UNITED STATES
NUCLEAR REGULATORY COMMISSION
WASHINGTON, D. C. 20555

Docket Nos. 50-259
50-260
and 50-296

RE: ACCEPTANCE CRITERIA FOR THE MARK I CONTAINMENT LONG TERM PROGRAM

NRC ACCEPTANCE CRITERIA
FOR THE
MARK I CONTAINMENT
LONG TERM PROGRAM

Figure 2.6-1 Schematic Diagram Illustrating the Methodology for Main Vent Impact and Drag

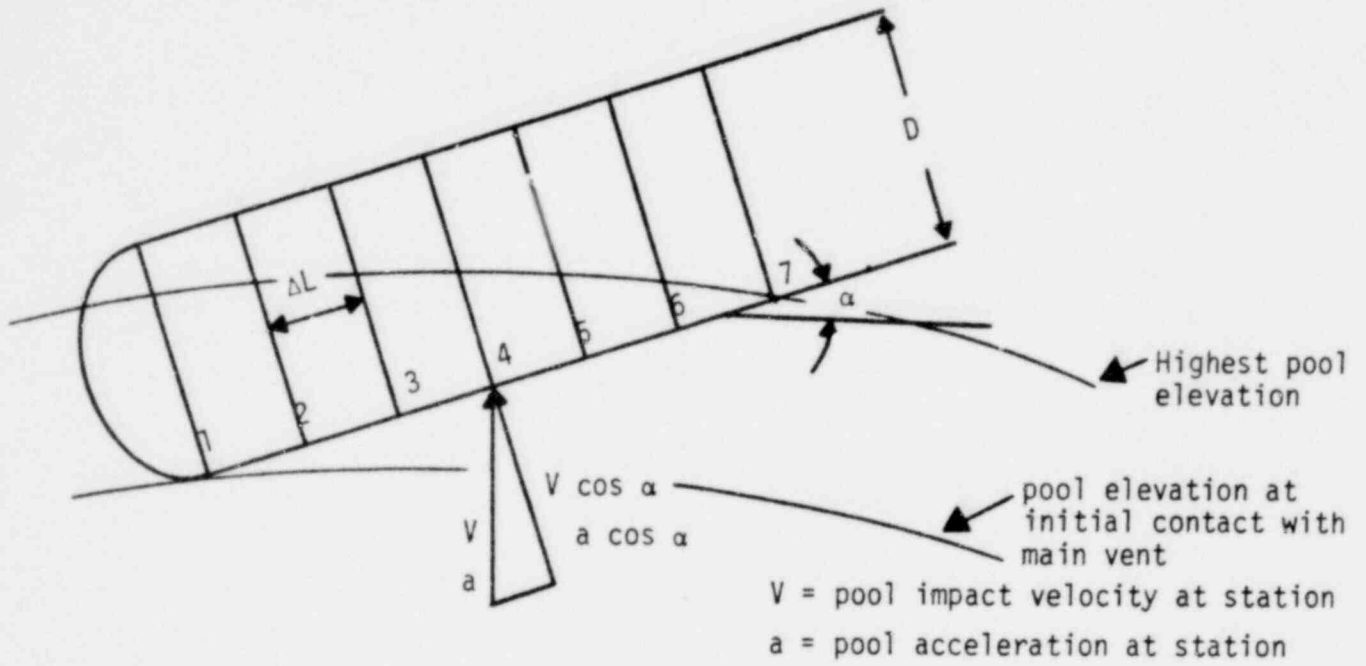
1. Subdivide the submerged portion of the main vent pipe into six equally wide segments (see Figure 2.6-1). If this subdivision results in $\Delta L < 0.3D$ fewer segments may be used such that $\Delta L \sim 0.3D$.
2. Determine the velocity and acceleration histories at Points 1 through 7 in Figure 2.6-1 from the QSTF data and appropriate corrections for longitudinal variations along the torus (at Point 7, only the initial impact velocity is required).
3. Using the velocity components normal to the vent pipe, calculate the impact and "steady" drag pressure using the method in Section 2.7.1 (Cylindrical Structures). At Point 7, only impact force is to be considered.

Using the acceleration components normal to the vent pipe, calculate the acceleration drag pressure using the equation

4. Sum the pressures due to impact, viscous drag and acceleration drag and multiply by D to obtain force per unit length at Stations 1 through 7.
5. To obtain a smooth loading history for the main vent as a whole, the linear interpolation method suggested for the vent header deflector in Section 3.5 of NEDO-24612 may be used.

Figure 2.7-1 Pulse Shape for Water Impact on Cylindrical Targets

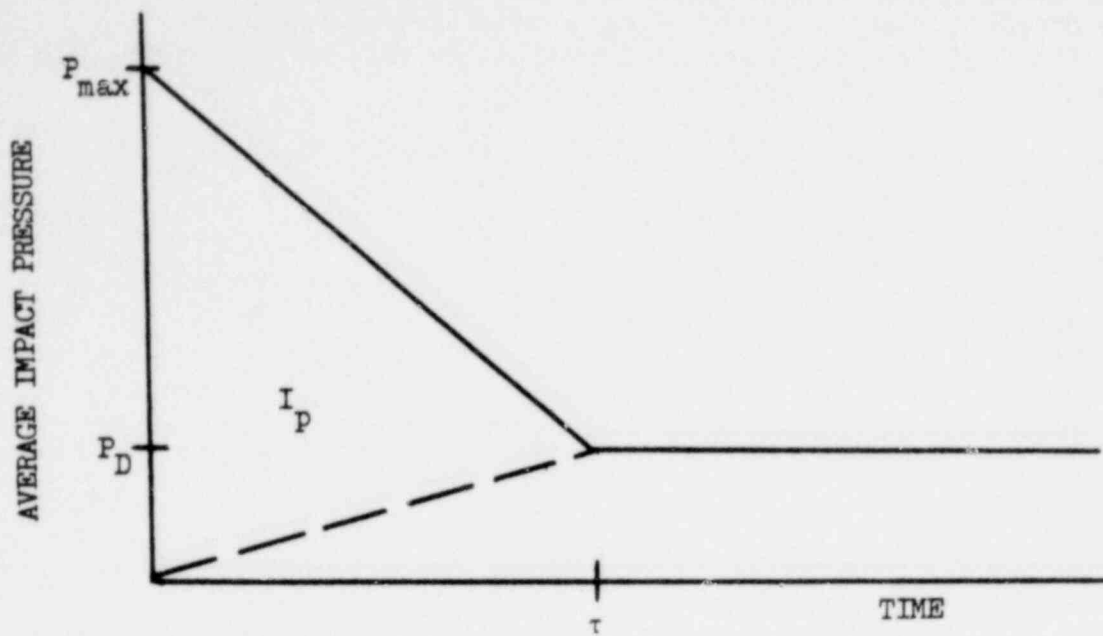
For cylindrical structures, the pressure transient which occurs upon water impact and subsequent drag is depicted in Figure 2.7-1. The parameters in Figure 2.7-1 shall be defined as follows:

1. The maximum pressure of impact P_{max} will be determined by

Figure 2.7-2 Drag Coefficient for Cylinders Following Impact

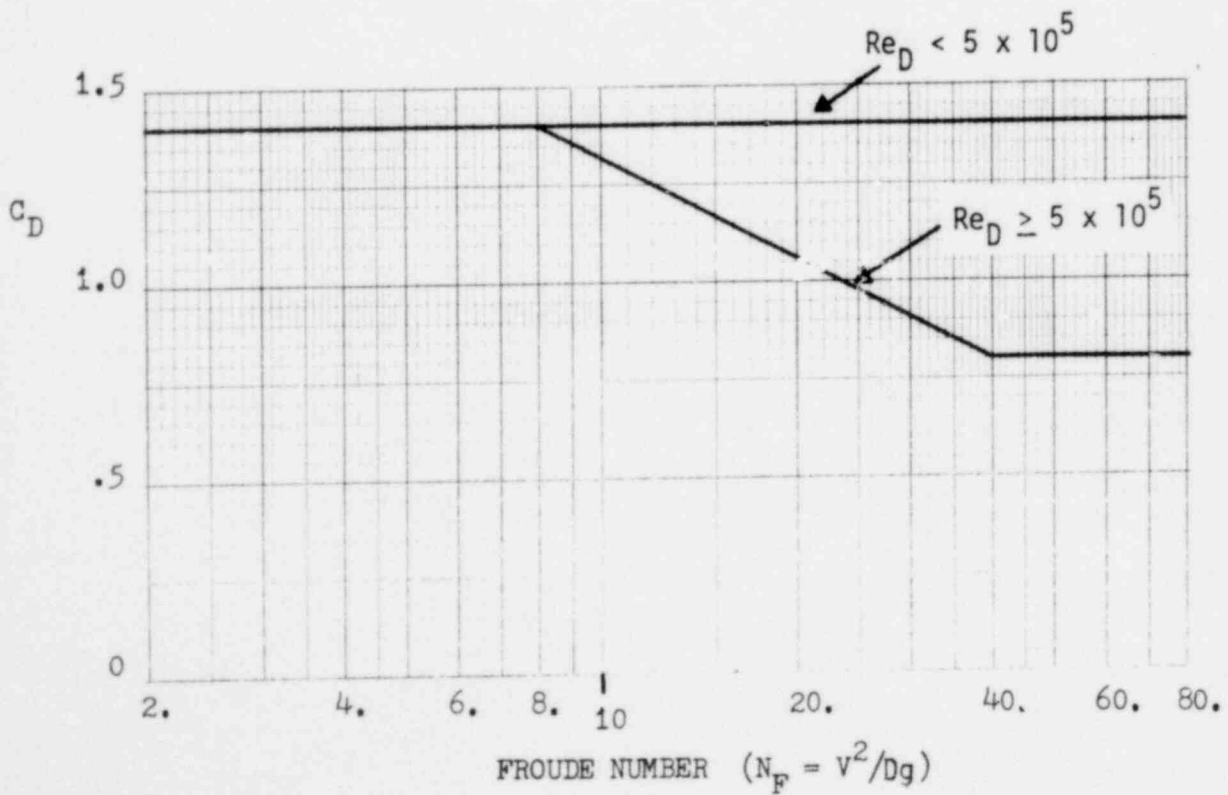
where P_D is the average drag pressure acting on the projected area of the target (psi), C_D is the drag coefficient as defined by Figure 2.7-2, and ρ is the density of water (lbm/ft³).

Figure 2.7-3 Pulse Shape for Water Impact on Flat Targets

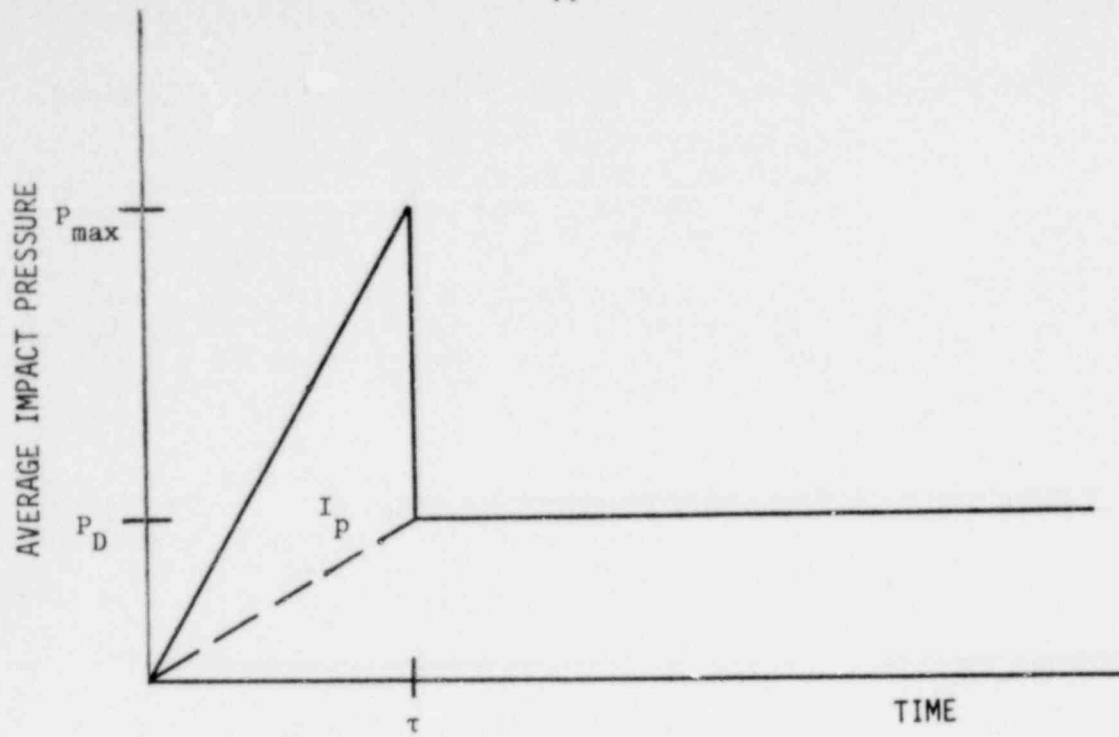
For flat-surface structures, the pressure transient which occurs upon water impact and subsequent drag is depicted in Figure 2.7-3. The parameters in Figure 2.7-3 shall be derived as follows:

1. The pulse duration (τ) is specified as a function of the impact velocity:

Figure 2.7-4 Pressure Drop Due to Flow Across Gratings

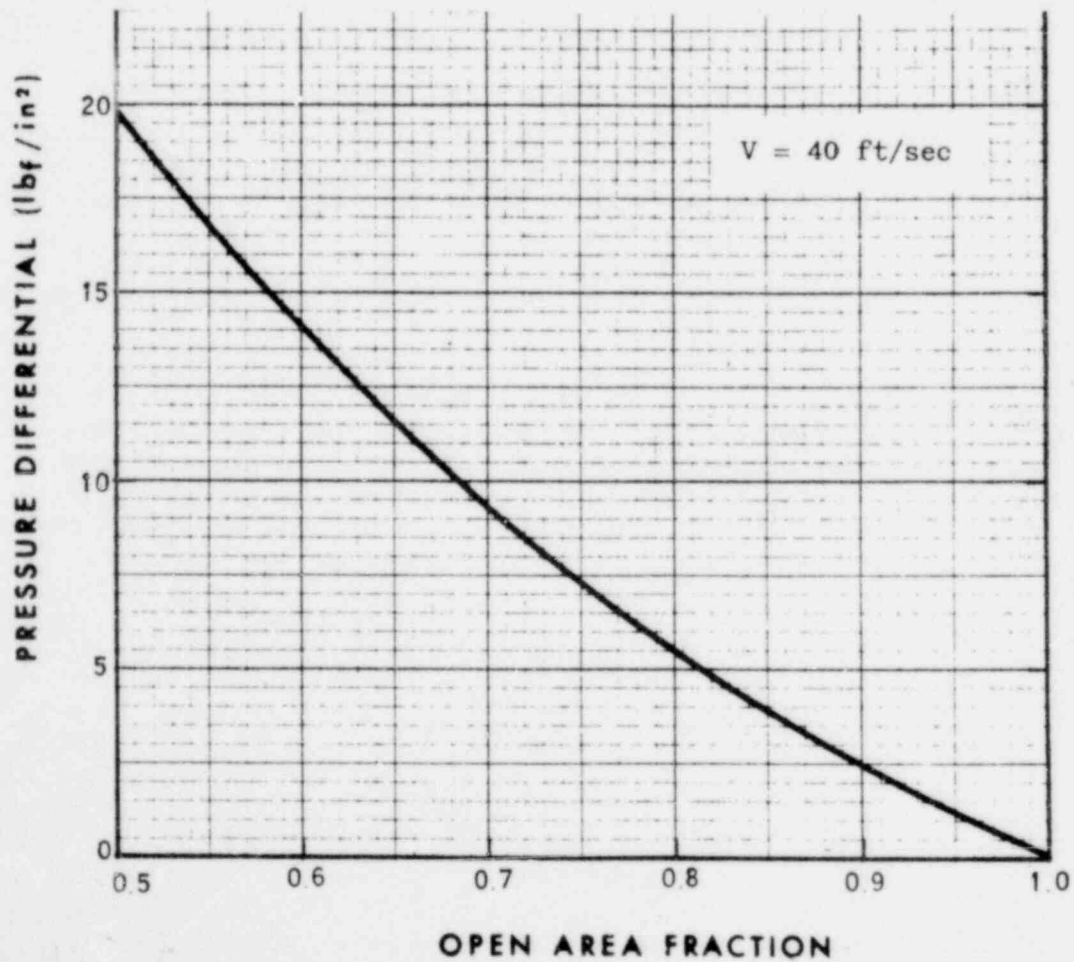
The static drag load on gratings in the pool swell zone of the wetwell shall be calculated for gratings with open areas greater than or equal to 60% by forming the product of the pressure differential (figure 2.7-4) and the total grating area (not only the area of the metal bars). The pressure differential curve in Figure 2.7-4 is based on a velocity of 40 ft/sec. If the maximum pool velocity in the area where gratings are located differs from 40 ft/sec, the force on the grating will be calculated as follows:

Figure 2.7-5 Impulsive Impact Loading Region for Structures with a Natural Frequency Less Than 30 Hz

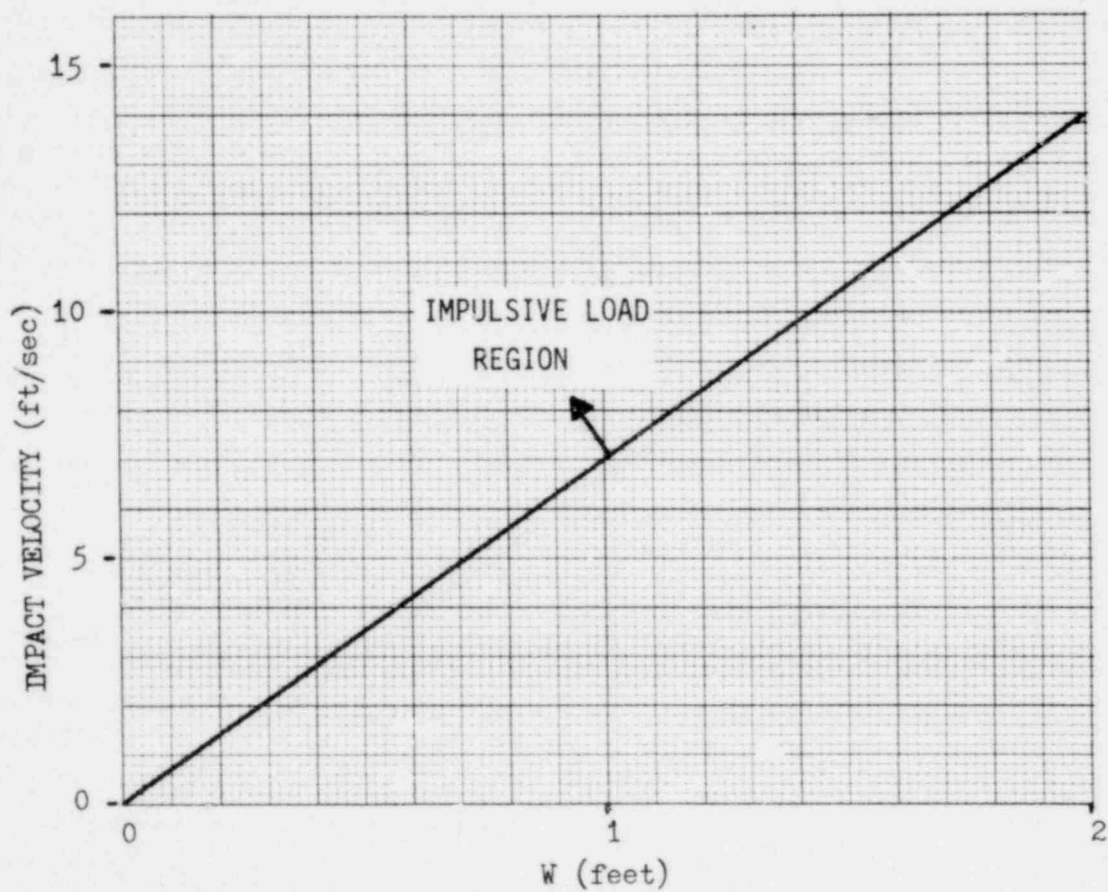
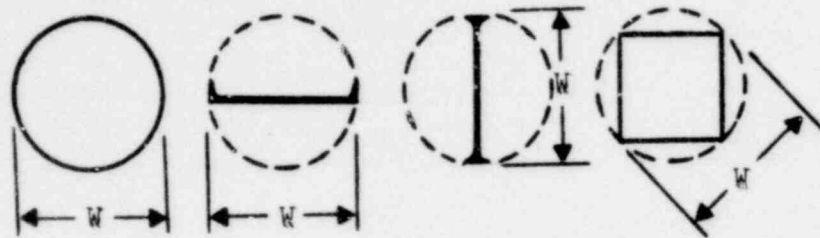
For structures with a natural frequency less than 30 Hz, loading can be treated impulsively (i.e., independent of pulse shape) when the conditions fall into the region above the straight line shown in Figure 2.7-5.

Figure 2.7-6 Effect of Drag Following a Parabolic Impact Pulse

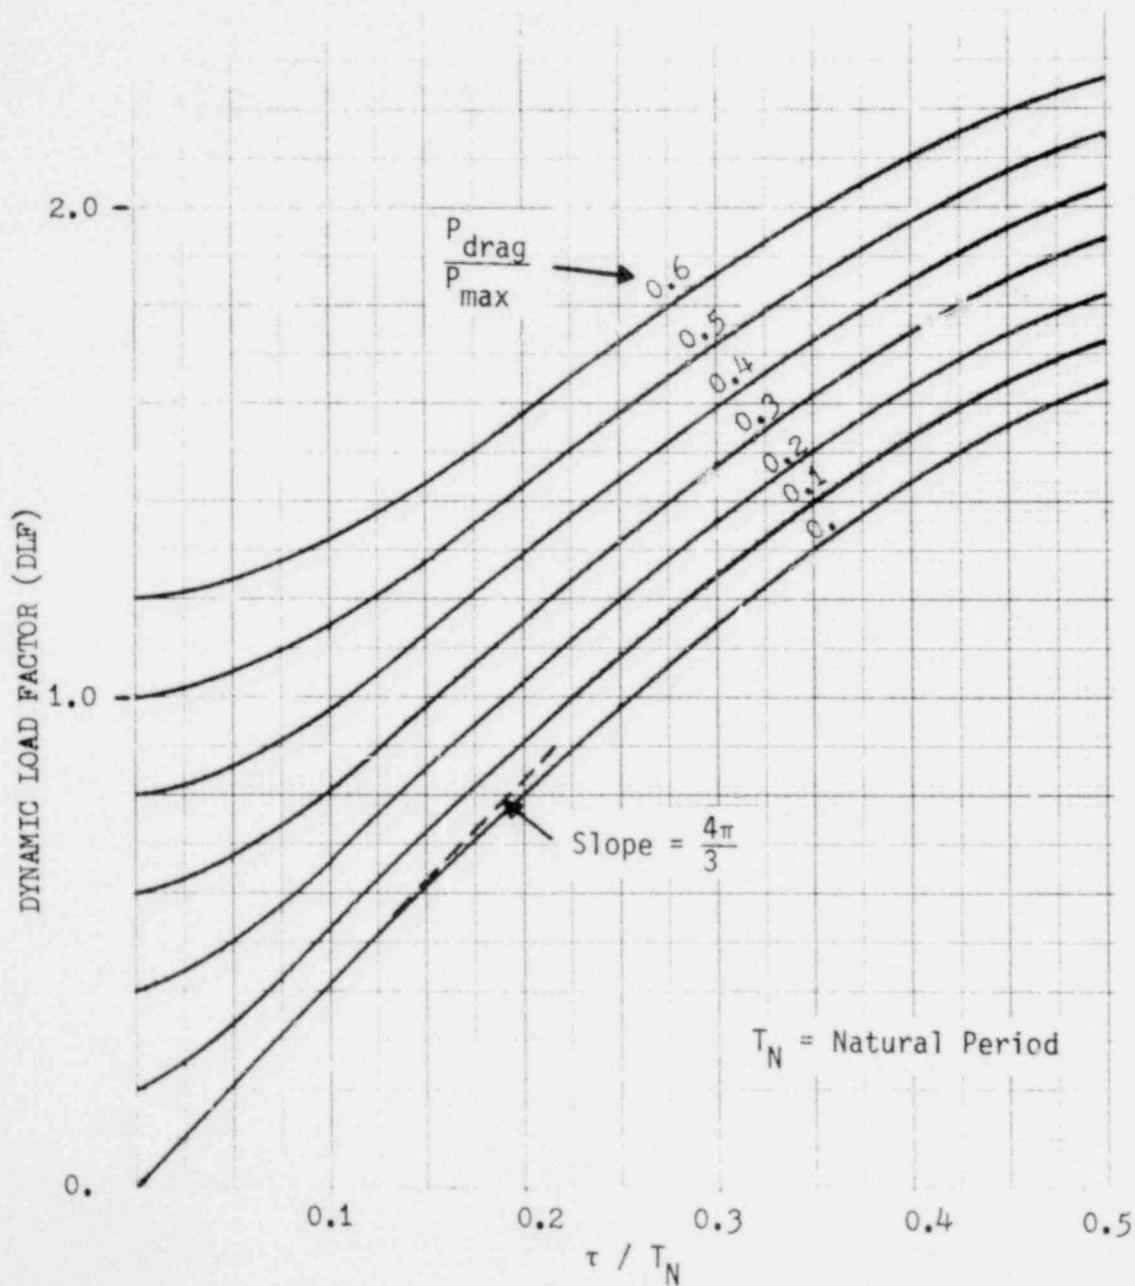
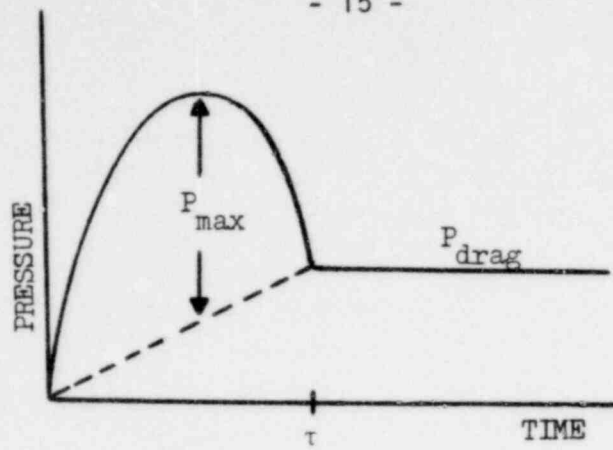
- c. Determine the dynamic load factor (DLF) from Figure 2.7-6, corresponding to the two cases: (1) parabolic pulse without drag and (2) parabolic pulse followed by drag.
- d. Multiply the calculated stress by the factor

Figure 2.10-1 Impact Force Transient for Addition to the Empirical Data for Deflector Types 1 - 3.

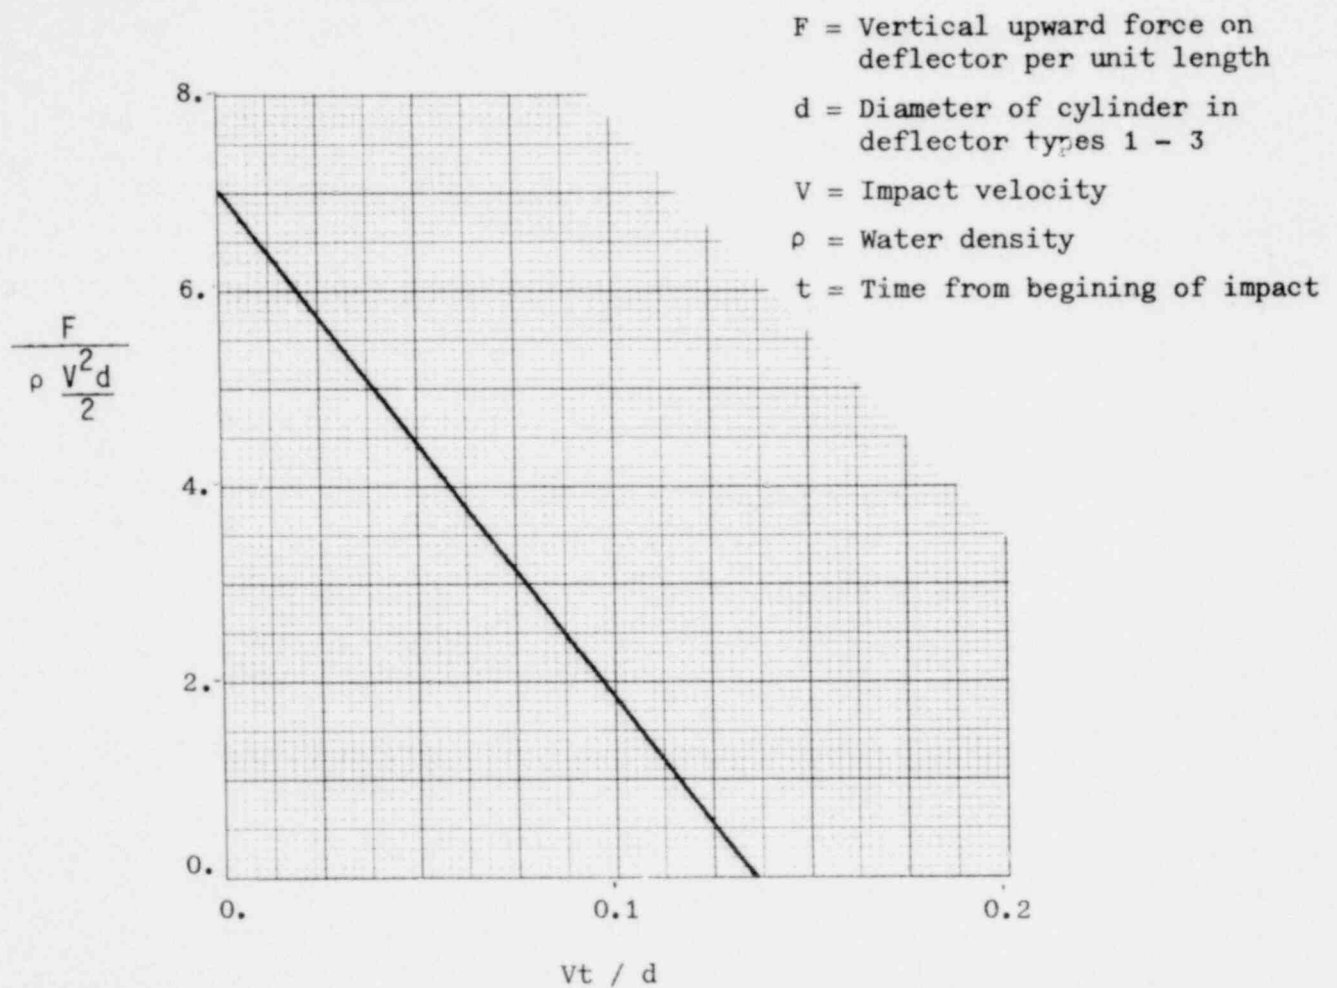
1. If the QSTF deflector load measurement does not have a sufficiently fast response time to resolve the initial impact pressure spike for the deflector types 1 - 3, inclusive, the loading transient shall be adjusted to include the empirical vertical force history of the spike shown in Figure 2.10-1. This impulse need not be applied for the type 4 deflector.

Figure 2.10-2 Impact and Steady Drag Force Correlation for Type 1 Deflector

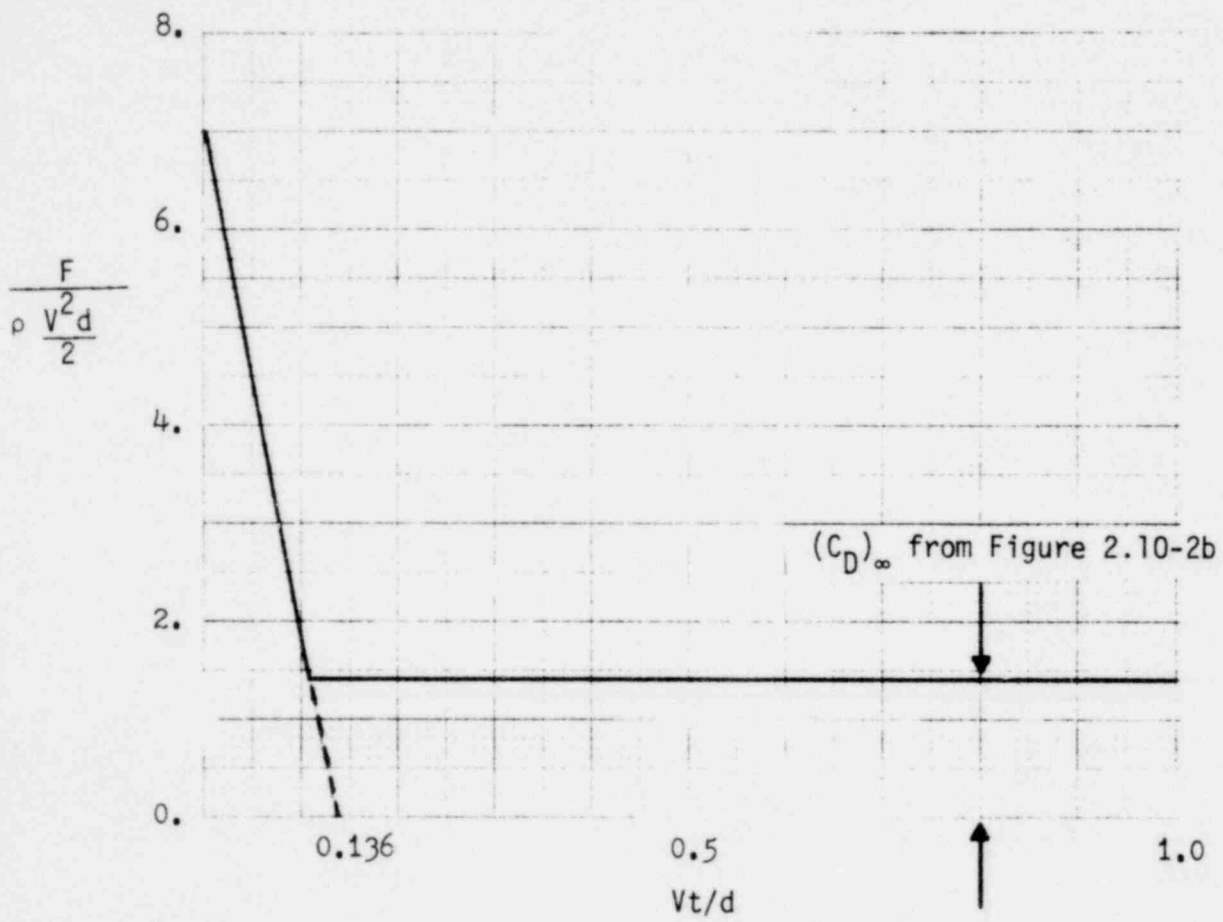
1. The impact transient and "steady drag" contributions to the load shall be computed from the correlations shown on Figures 2.10-2 through 2.10-5, for deflector types 1 - 4, respectively. For times past the periods shown, the last value shall be extended for the duration of the transient.
2. The three-dimensional load variation and timing shall be based on the EPRI "main vent orifice" tests, as discussed in Section 2.5.
3. The gravitational component of the acceleration drag shall be included in F_A , as defined in NEDO-24612.
4. In computing the deflector response to the load, the added mass of the water shall be accounted for, as described in Section 2.10.1.3 above.
